Work Order ID 150304***150304***

Item Name: Bracket

APICAL INDUSTRIES, INC.	ENGINEERING CHANGE NOTICE NO. 03697				SHEET 1 OF 1	
	DWG NO. 646.3800	REV: N/C	PREPARED BY B. PETERS	DATE: 11/14/12	EFFECT ON DWG ☐ INC. ☒ UNINC.	
	DWG TITLE: BRACKETS					
	APPROVED BY: ENGR <i>[Signature]</i>	MFG <i>David Baker</i>	QC <i>[Signature]</i>	EFF: NEXT ORDER		
TRANSACTION CODES (TC): A-ADD C-CREATE R-REVISE D-DELETE	REASON: ADDED ALTERNATE MATERIAL.				ECR: D-12-006

SHEET 1, ZONE A2 IS:

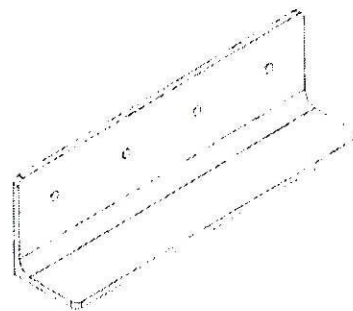
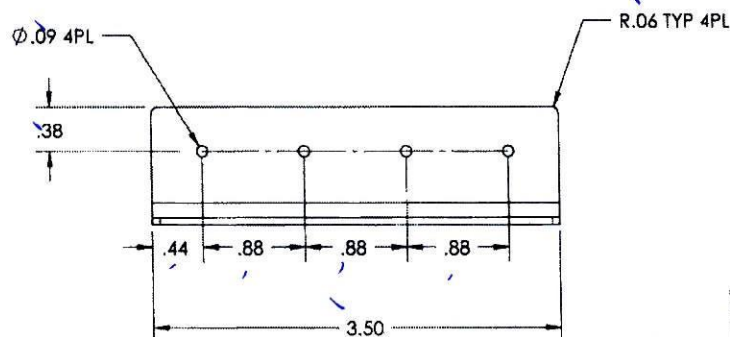
1 PRIMARY MATERIAL: 7075-T651 ALUMINUM PER AMS-QQ-A-250/12.
ALTERNATE MATERIAL: 7075-T6511 ALUMINUM PER AMS-QQ-A-200/11.
